SUBJECT: COMANCHE PEAK NUCLEAR POWER PLANT, UNITS 3 AND 4
DOCKET NUMBERS 52-034 AND 52-035
RESPONSES TO REQUEST FOR ADDITIONAL INFORMATION NO. 5317
(SECTION 3.7.1), NO. 5411 (SECTION 6.4), AND NO. 5465 (SECTION 2.3.1)

RAI NO.: 5317 (CP RAI #205)

RAI NO.: 5411 (CP RAI #202)

RAI NO.: 5465 (CP RAI #204)

Figure 1 – Site Response Soil Column Analysis Results Showing Ground Surface Acceleration Response Spectra for Four Soil Profiles due to Rock Outcrop Motion Applied at Foundation Level

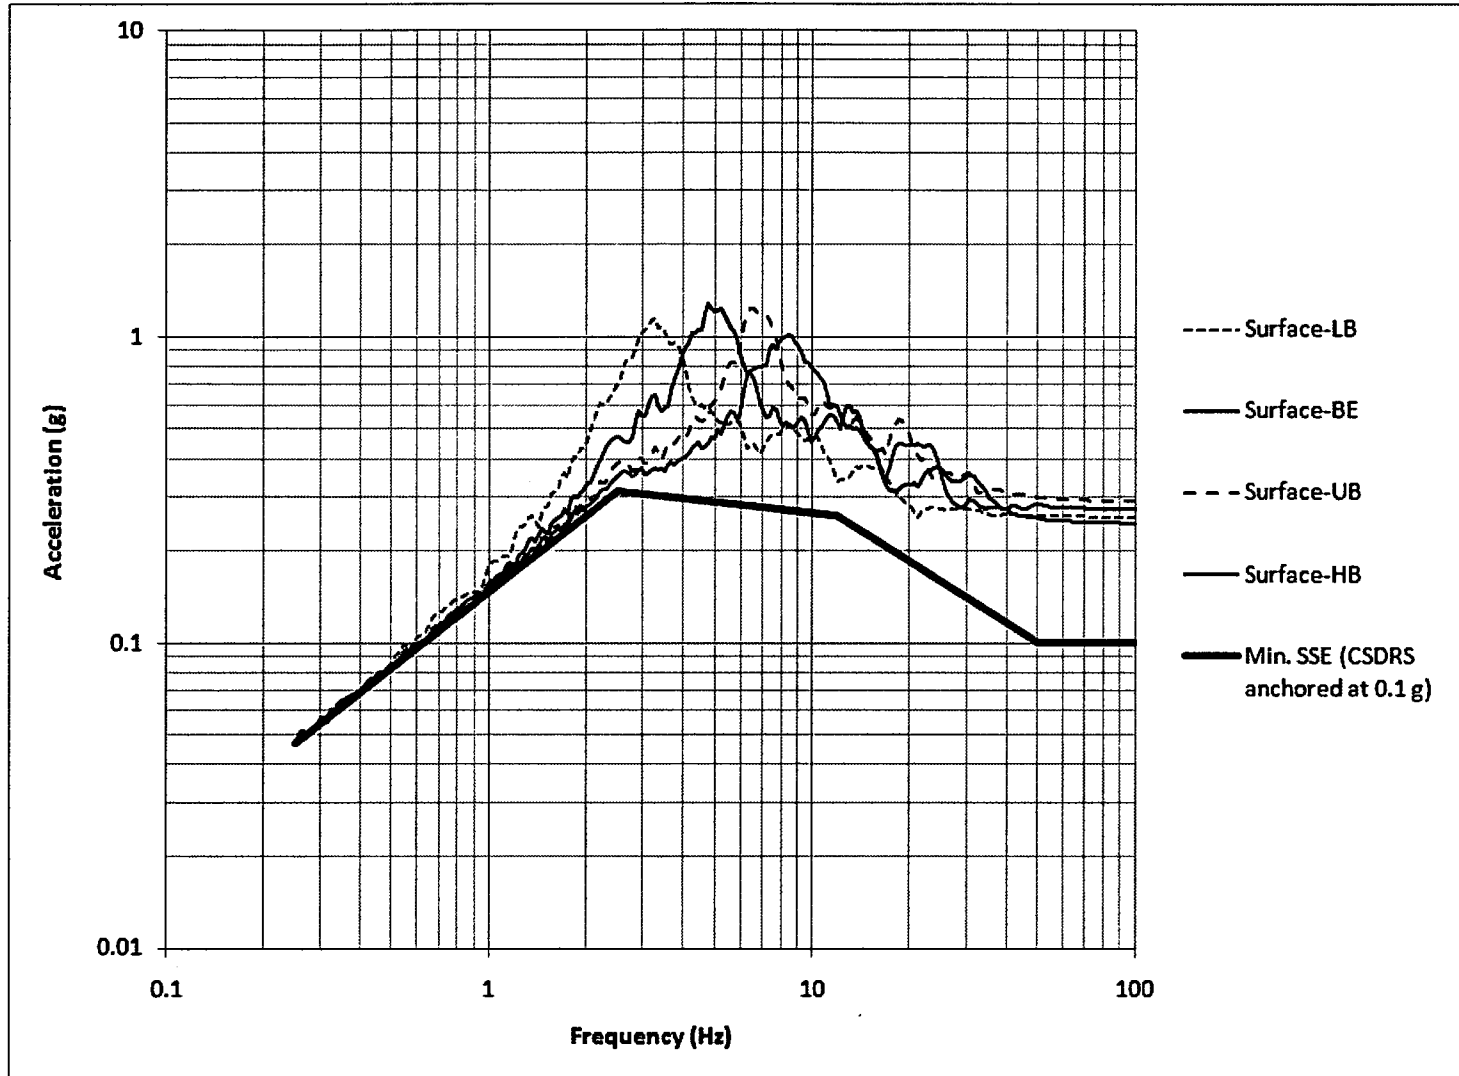
In response to RAI 3.7.1-3 Luminant has stated that the development of foundation input response spectra (FIRS) 1, FIRS 2, and FIRS 3 is consistent with the recommendations of NEI (2009) *Consistent Site-Response/Soil-Structure Interaction Analysis and Evaluation* for embedded structures that are analyzed as surface structures. To date, the soil-structure interaction (SSI) analysis performed in support of the US-APWR Standard Plant has treated embedded structures as surface structures. In contrast, in the SSI analysis of the CPNPP structures, embedded structures are analyzed as embedded structures, not surface structures.

Consequently, FIRS 1, FIRS 2, and FIRS 3 that were developed for treating embedded structures as surface structures will not generally be the same FIRS for analyzing embedded structures as embedded structures. Section 3.2.3 of NEI gives a multi-step process for developing FIRS to be used when analyzing embedded structures as embedded structures. Provide justification for using FIRS 1, FIRS 2, and FIRS 3 as the basis of comparison for determining the proper seismic input to the CPNPP structures and describe how the current approach does or does not meet the guidelines of DC/COL Interim Staff Guidance-017 (which adopts the methodology of NEI [2009]).

Figure 1 shows the horizontal ground motion acceleration response spectra (ARS) calculated in the site response analyses. The figure shows the 0.1 g CSDRS and surface ARS calculated for each of the four soil cases: lower bound (LB), best-estimate (BE), upper bound (UB) and high bound (HB) as indicated. The 0.1 g CDSRS motion was input as outcrop motion at the foundation level at top of limestone. The resulting ground surface ARS are significantly higher than the outcrop motions input at rock level.

ISG-017 and the associated NEI document require the motions applied to exceed the performance-based spectra developed at foundation level (FIRS) and at surface level (PBSRS). The performance based surface response spectra (PBSRS) corresponds to FIRS3 or FIRS4 identified in FSAR Figure 3.7-201. The input motion applied exceeds the FIRS3 and FIRS4 values by a significant margin at all frequencies. None of the spectra in FSAR Figure 3.7-201 directly represent outcrop FIRS response for embedded structures, however based on Figure 1, surface spectra are higher than the foundation level outcrop motion for this soil column. Therefore, the performance-based FIRS will be lower than FIRS3 and FIRS4
